BRANSON WEST MUNICIPAL AIRPORT – EMERSON FIELD

ADDENDUM NO. 1

Project No. AIR 206-099A-1

**CONSTRUCT TAXILANE, FOUR-UNIT T-HANGAR AND TWO BOX
HANGARS**

HANGAR DETAILS

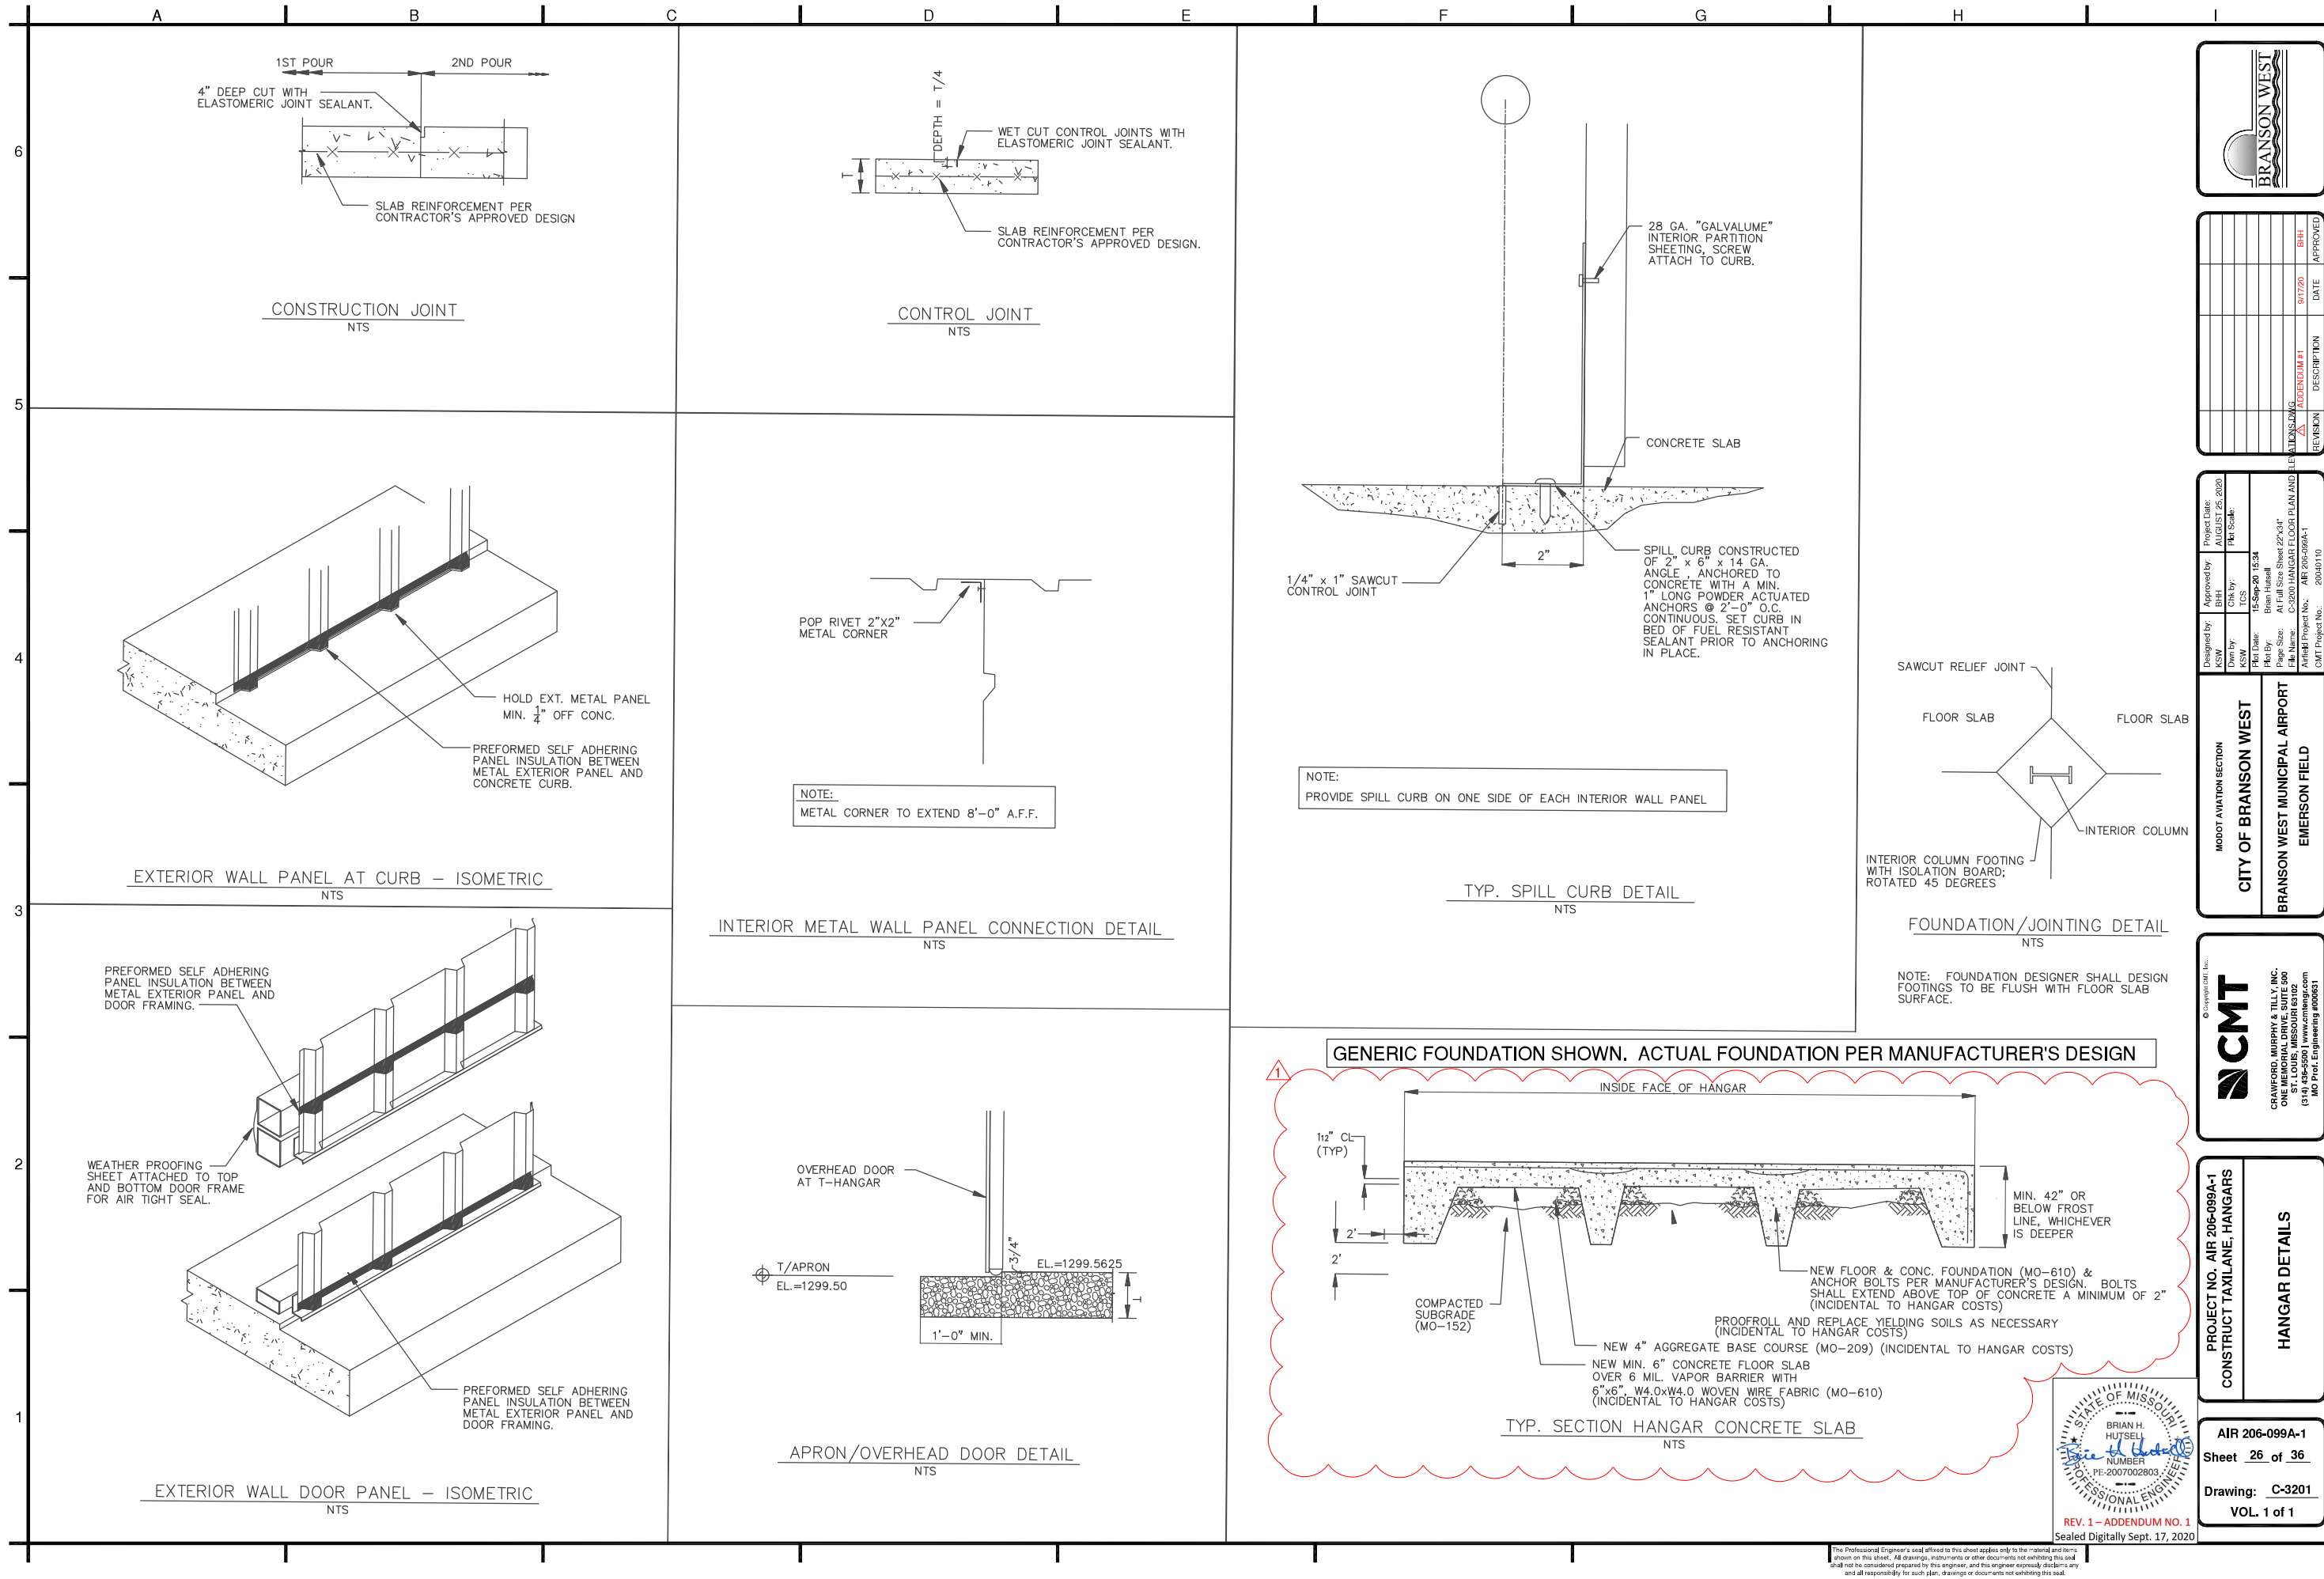
CLARIFICATION: This sheet is clarifying the minimum hangar slab and aggregate base thickness, as well as the incidental nature of that work to the hangar pay items.
